L15/D2A

CHRISTMAN 4 PLEX

DRAINAGE CERTIFICATION

AS BUILT
GRADING & DRAINAGE PLAN
CHRISTMAN FOUR-PLEX

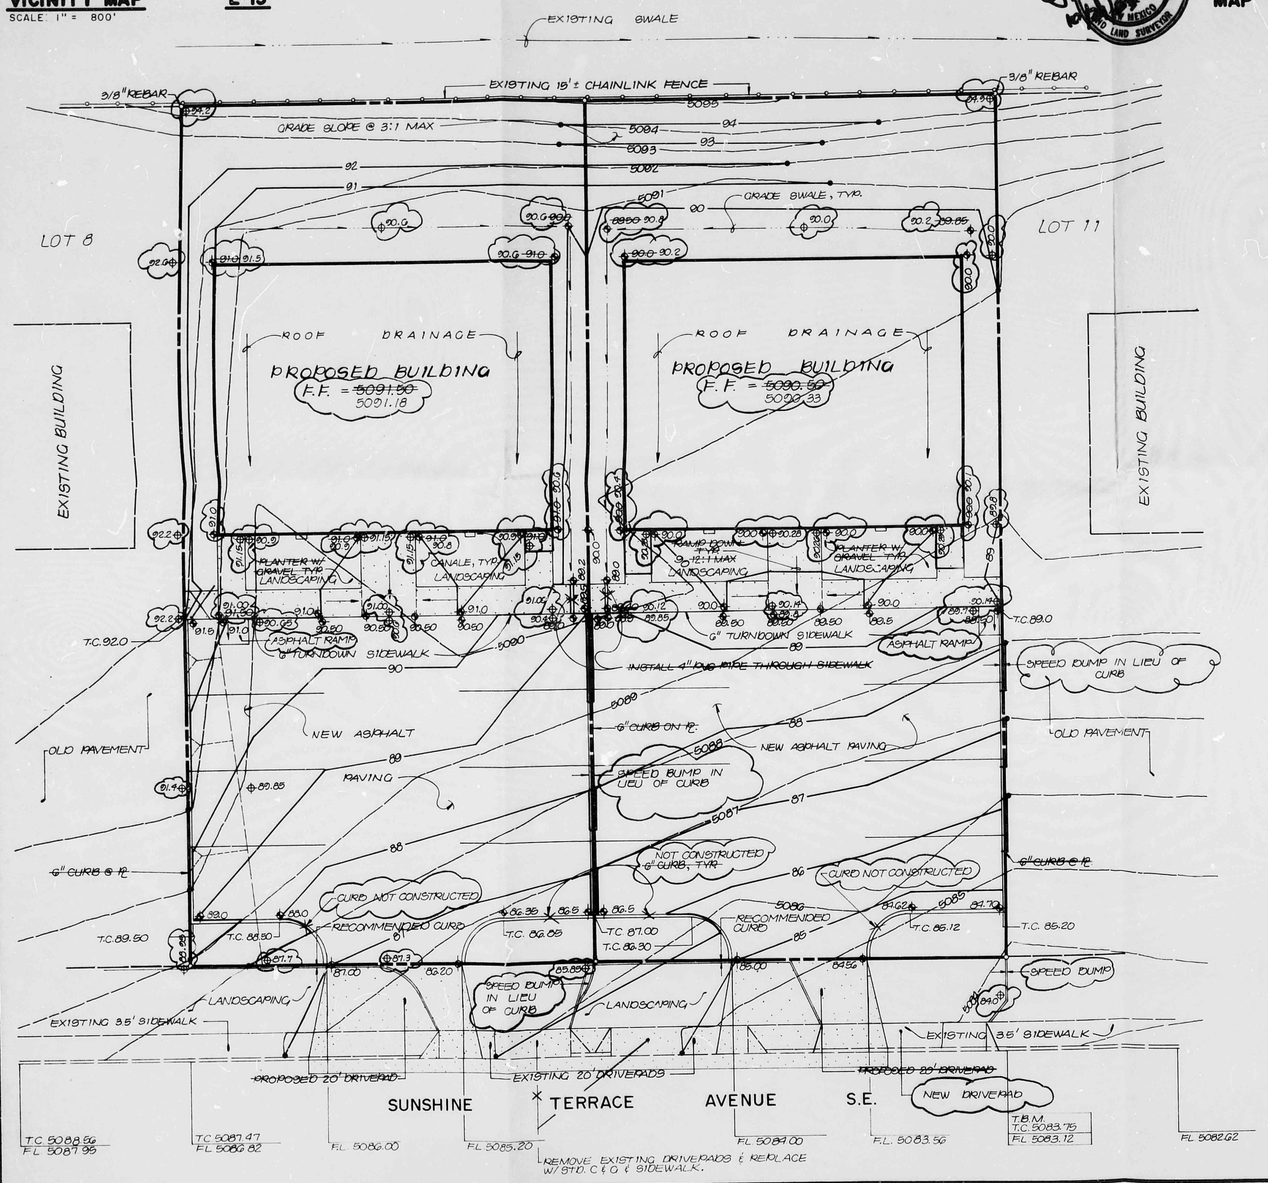
The plan contained hereon shows (1) design grades indicated by spot elevations and contours, (2) as-built spot elevations at key locations, and (3) changes to the approved plan.

The as-built conditions of the project are in substantial compliance with the approved drainage plan. This has been determined by field visits and survey information. The building finish floor elevations are approximately 2 to 3 inches lower than designed, however this does not present a problem. The survey information is the basis for the as-built spot elevations shown on this plan. Furthermore, the as-built conditions are compatible with the approved drainage plan, adjacent property and the street grades.

Asphalt speed-bump like curb was constructed in lieu of concrete curb to control runoff, but accomodate vehicular traffic. Because of this, cross-lot drainage has been avoided. Also, the roofs drain to the front, i.e. the south, as designed, therefore, the only runoff experienced by the backyards is generated by that rainfall which falls on the backyard area. Runoff may leave portions of the paved parking area, cross the landscaped area adjacent to the street and finally cross the sidewalk to enter the street. It is because of this that the addition of an asphalt curb/speed bump is recommended to assure compliance with City of Albuquerque criteria.
